Service Bulletin

Subject: Clunk Noise Under Vehicle When Accelerating

Brand:	Model:	Model Year:		VIN:		Engine:	Transmission:
		from	to	from	to		
Cadillac	CTS	2008	2014			All	All

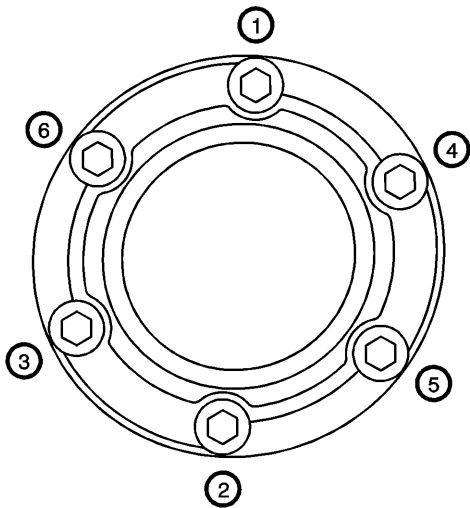
Condition	Some customers may comment on a clunk noise originating from the underside of the vehicle upon acceleration.
Cause	This may be caused by a loss of clamp load at the joint that attaches the propshaft to the transfer case.
Additional Options	Equipped with All Wheel Drive (RPO MX7)

1. Raise and support the vehicle. Refer to Lifting and Jacking the Vehicle in SI.
2. With the vehicle in the air, visually inspect the propeller shaft CV joint to transfer case flange bolts for looseness.
 - If any of the bolts are loose, continue to Step 3.
 - If all the bolts look secure, continue with diagnosis referring to SI.
3. If one or more of the bolts are visually loose, replace all six of the propeller shaft CV joint to transfer case flange bolts.

- When replacing the bolts, be sure to install and tighten in sequence (1–6) to 40 Y (29 lb ft) as illustrated above.
